OYSTER CREEK NUCLEAR GENERATING STATION
PROVISIONAL OPERATING LICENSE NO. DPR-16
DOCKET NO. 50-219
TECHNICAL SPECIFICATION CHANGE REQUEST NO. 120

Summary of Tech. Spec. Change Request No. 120

FIGURE 6.22
ONSITE ORGANIZATION

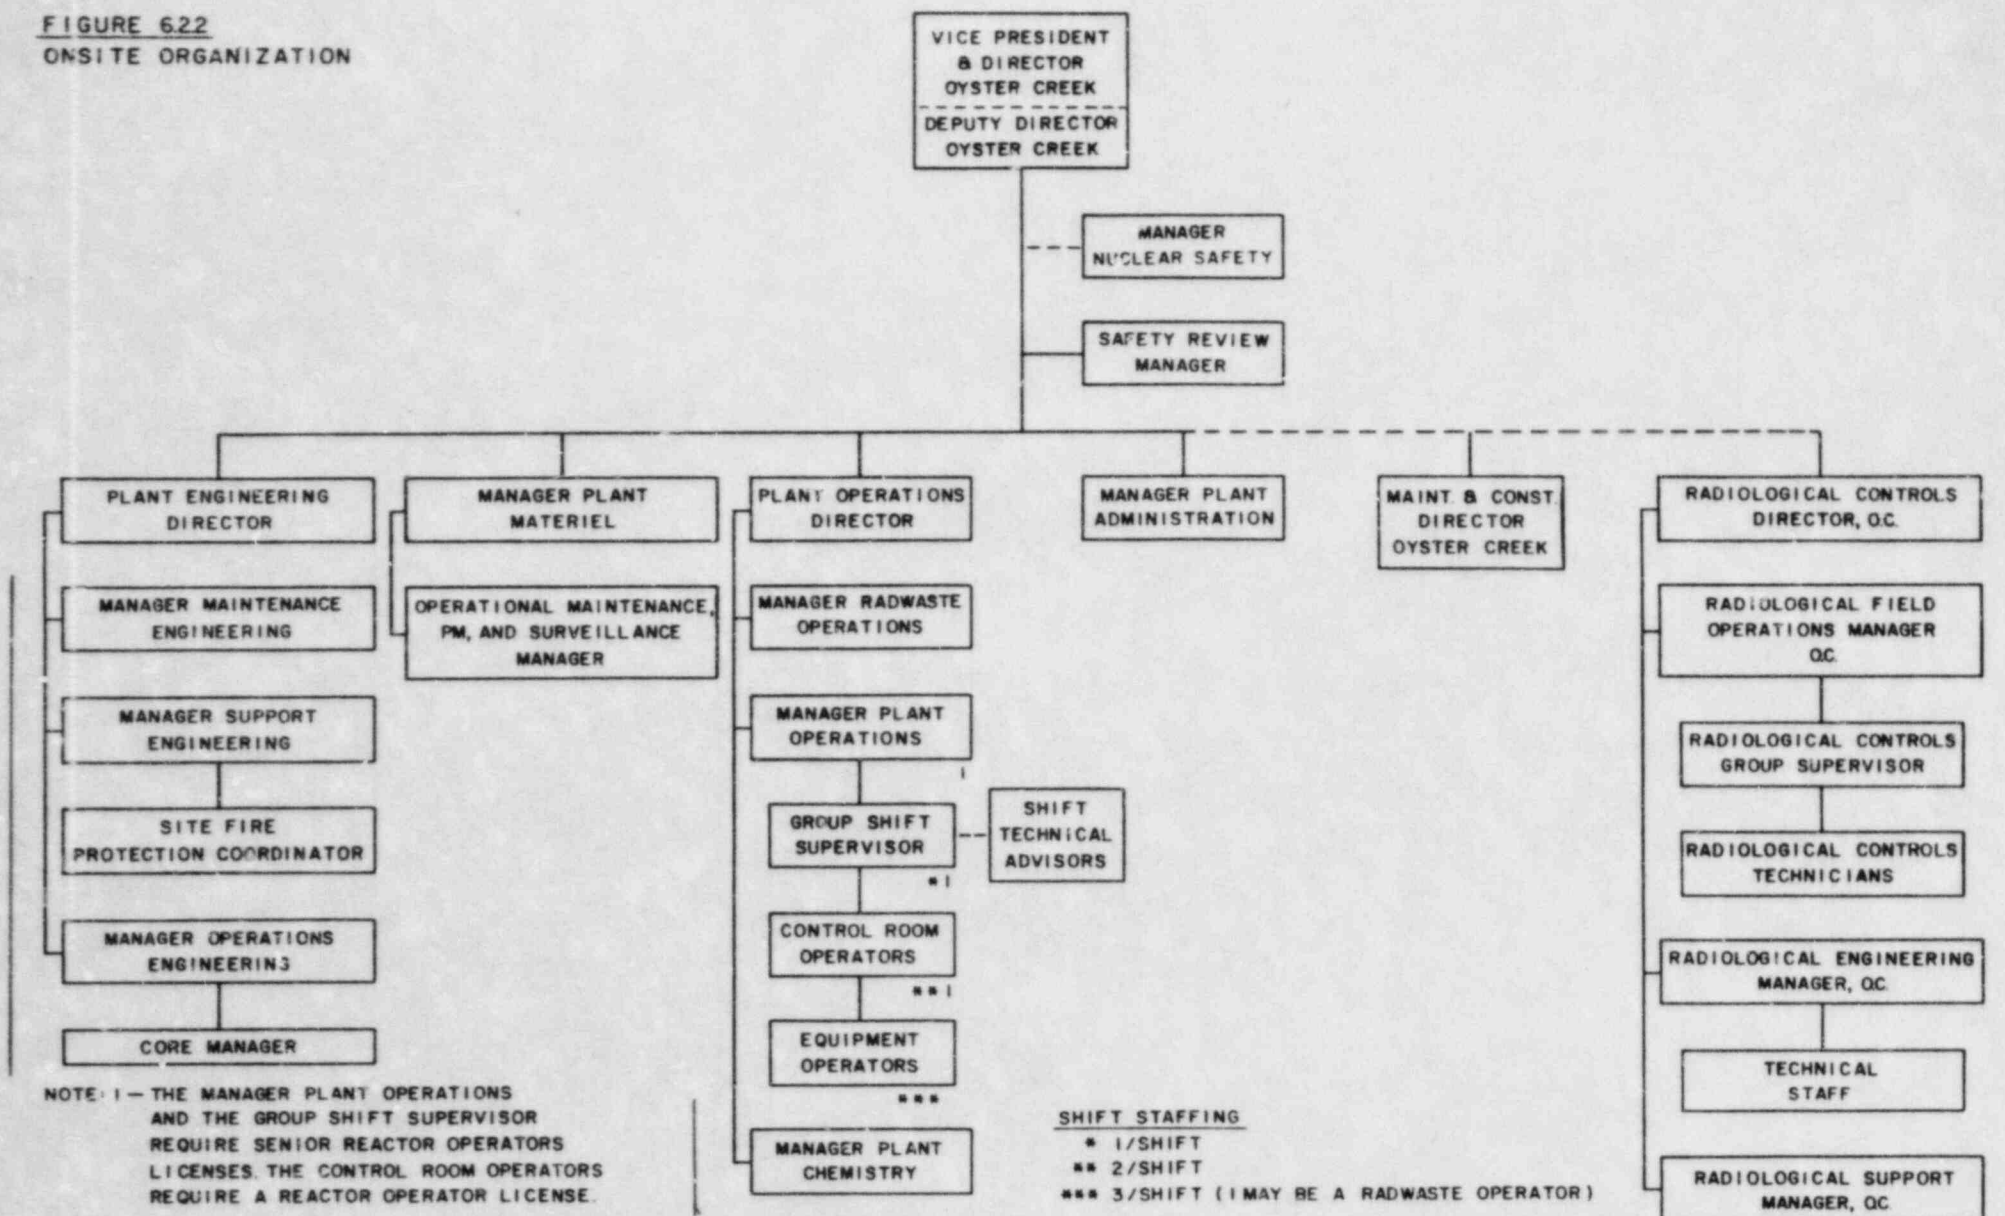
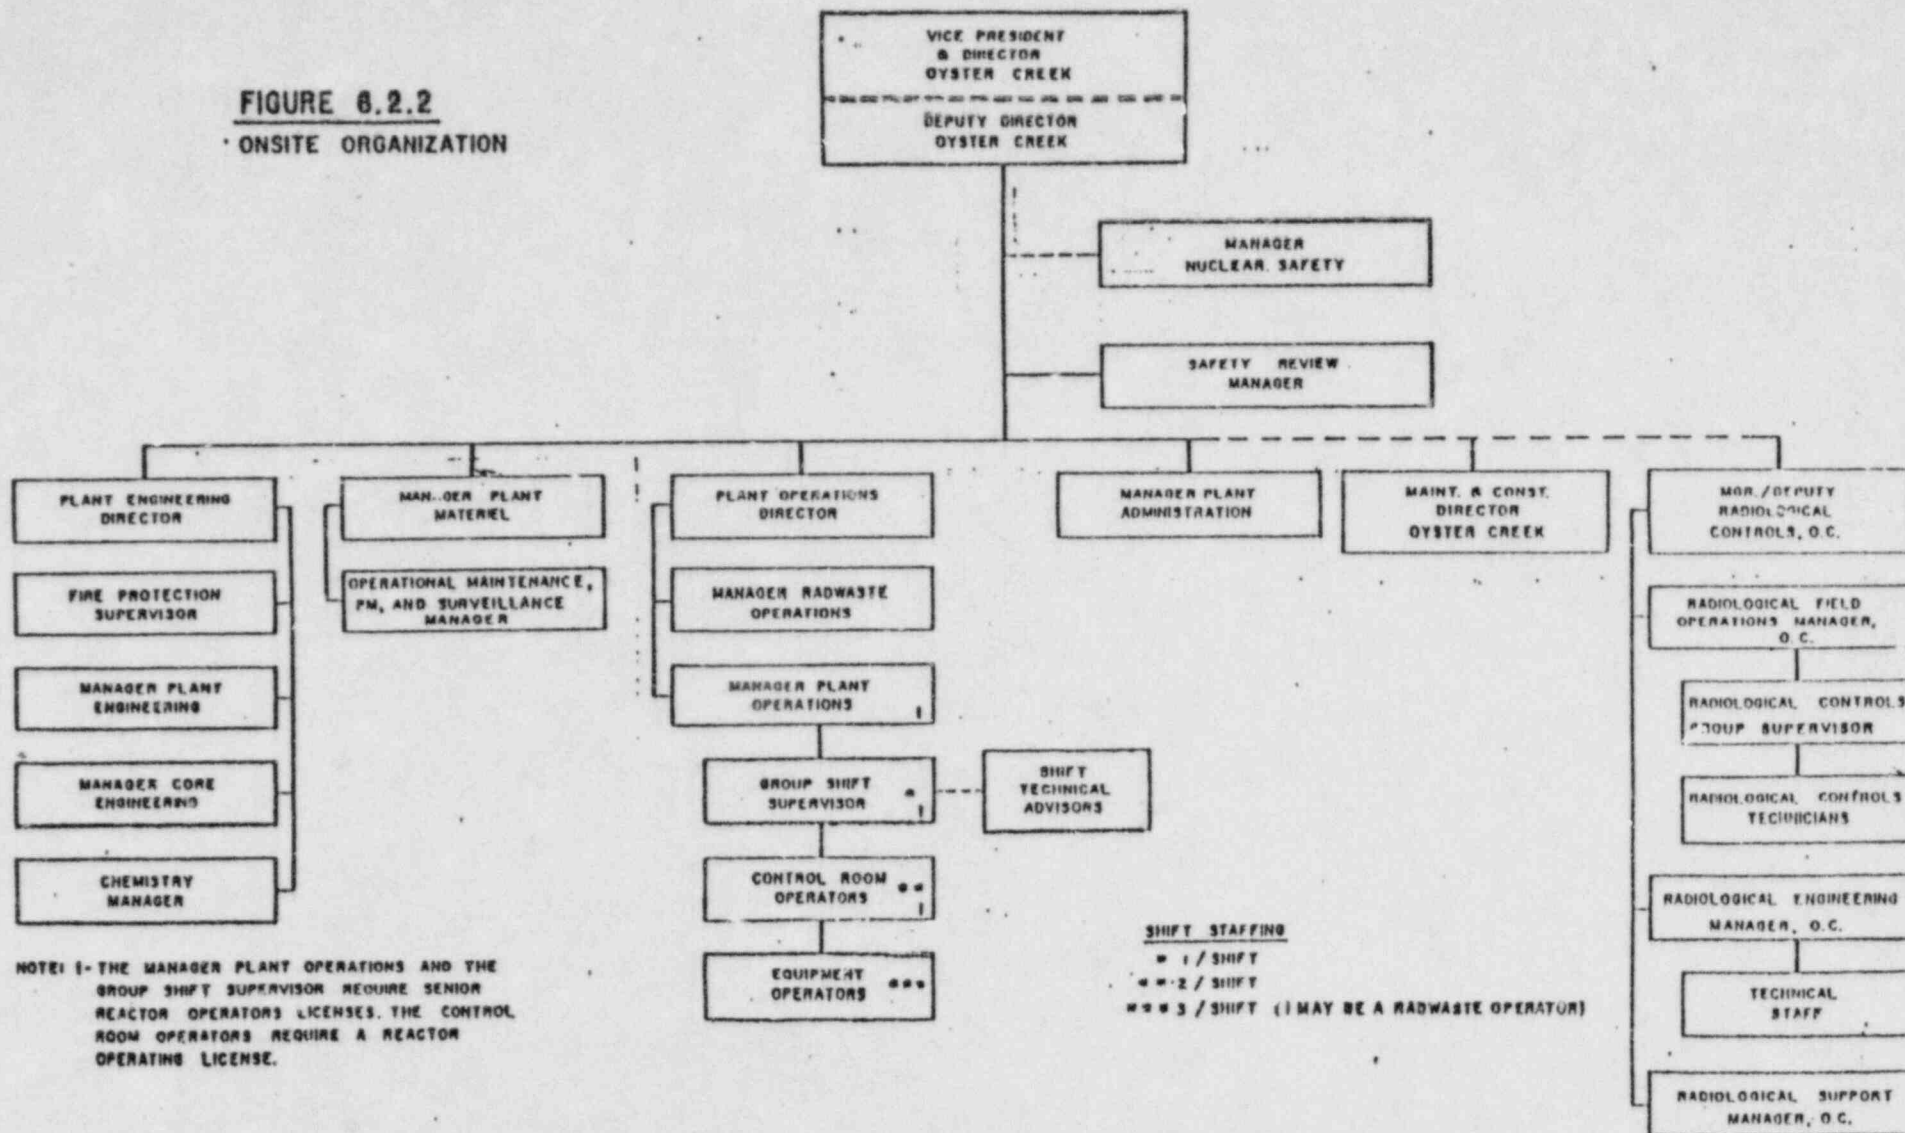
The primary reason for this change request is to submit a Plant Engineering organization which is more responsive to the continuing operations and maintenance needs of the Oyster Creek Facility and to enhance the administrative capabilities of the organization.

- a. Reducing the number of direct interfaces to both the Plant Engineering Director and the Manager - Plant Engineering.
- b. Provide a three Manager structure with specific responsibilities in the areas of Operations, Maintenance, and Support.
- c. Provide direct interfaces with Plant Engineering for the related organizations of the Oyster Creek division and GPUN.
- d. Assigning specific responsibility to a dedicated group for discharging the administrative functions of Plant Engineering.

Another change that is being made within the organization at Oyster Creek is that the position of Manager, Radiological Controls has been upgraded to the Director level. The Technical Specification requirements for this position remain the same.

<u>No.</u>	<u>Current Tech. Spec.</u>	<u>Proposed Tech Spec.</u>	<u>Extent of Change</u>	<u>Justification</u>
1.	Figure 6.2.2 Page 6-4	Figure 6.2.2 Page 6-4	Figure redrawn to reflect reorganization of Oyster Creek Onsite Organization within Plant Engineering, Plant Operations, and Radiological Controls	GPUN approved administrative change
